THE FOLLOWING ADDENDUM SUPERCEDES INFORMATION CONTAINED IN DRAWINGS AND SPECIFICATIONS ISSUED FOR THE PROJECT TO THE EXTENT REFERENCED. THIS ADDENDUM FORMS PART OF THE TENDER DOCUMENTS AND IS SUBJECT TO ALL OF THE CONDITIONS SET OUT IN THE CONTRACT CONDITIONS.

This electrical addendum contains four (4) page. Plus one (1) page for Site Plan, one (1) page for Distribution Diagram, one (1) page for Grounding, and one (1) page for Under the Pier Photo's for a total of eight (8) pages.

SAR - PRINCE RUPERT
ADDENDUM E1

SITE PLAN

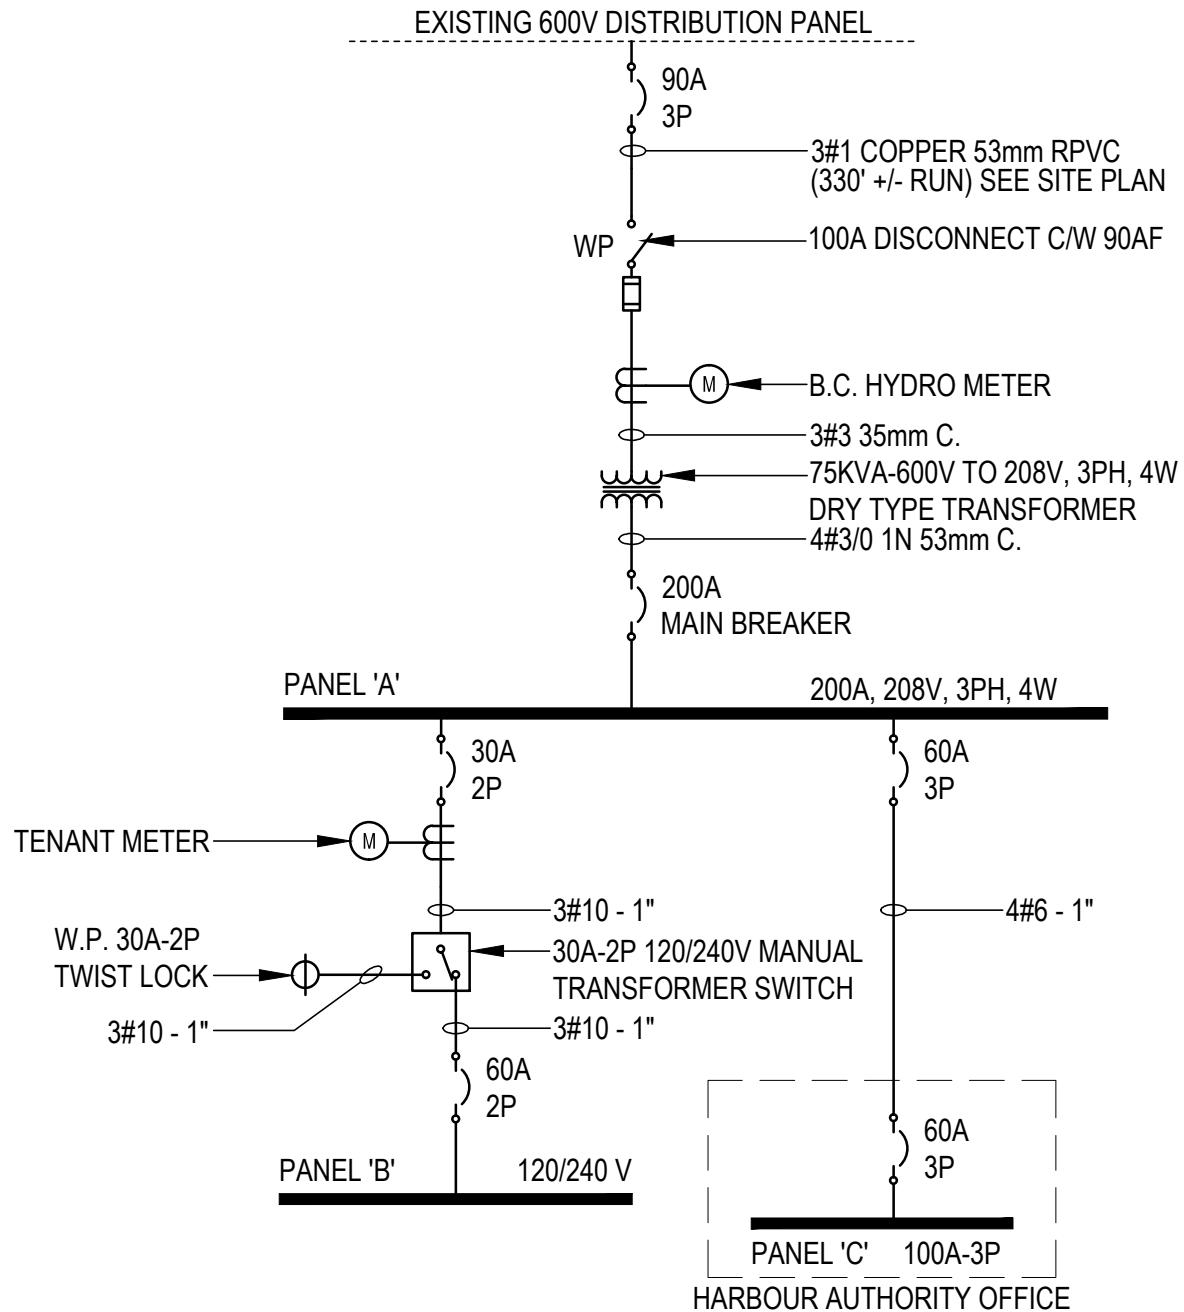
- .1 Provide 90A breaker and 3 #1copper in 50mm RPVC from Main Hydro cabinet, to 100A exterior disconnect on building (estimated only run of 330').
- .2 Provide 2 x 50mm RPVC conduits from SAR communication cabinet and 2 x 50mm RPVC conduit Harbour Authority communication backboard to under pier cable trays.

- .1** Where will the main services and communication services be tied into.

- .5 The single line on drawing E2.0 (detail 5/E2.0) should the new building being fed from “Existing 600V distribution panel”
- a) No location provided for the panel.

- .1** The Main Service is located adjacent the ferry terminal (BC Hydro). See attached site plan.

See attached site plan for location of Main Hydro Service (adjacent ferries).

DISTRIBUTION DIAGRAM

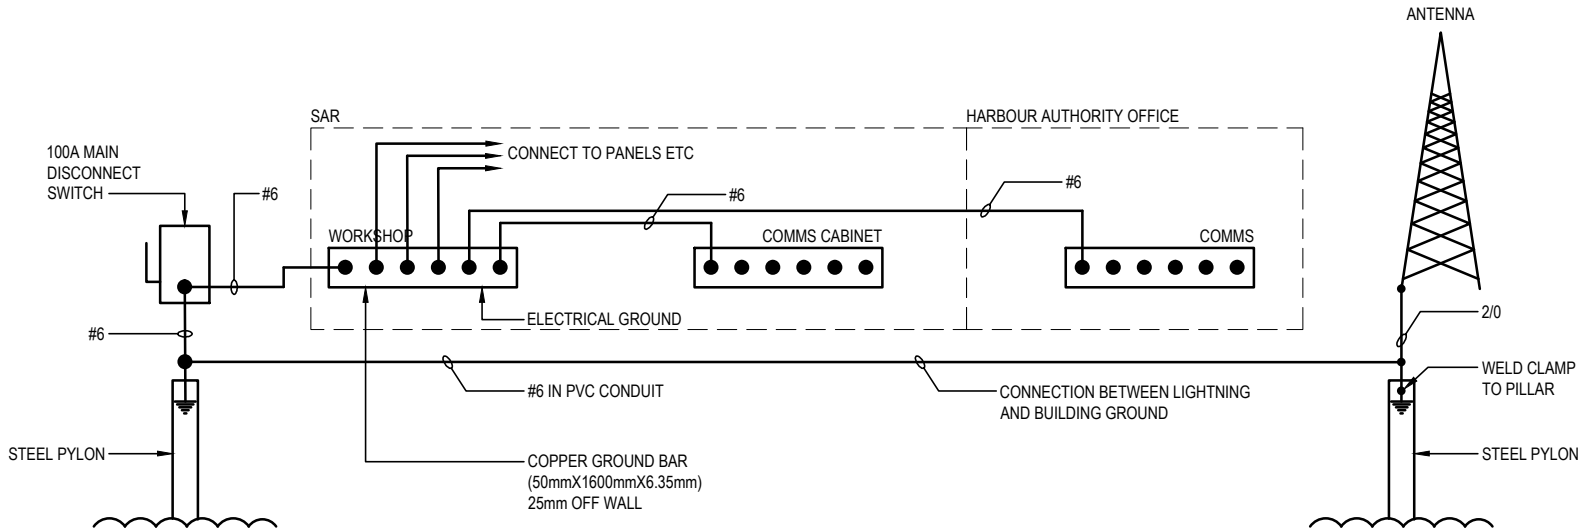
- .3 Single line Diagram shows a 45kVA transformer and the layout shows a 75kVA transformer
- a) What is required?

75 kVA transformer 600V to 120/208V, 3Phase, 4 wire required. See revised distribution.
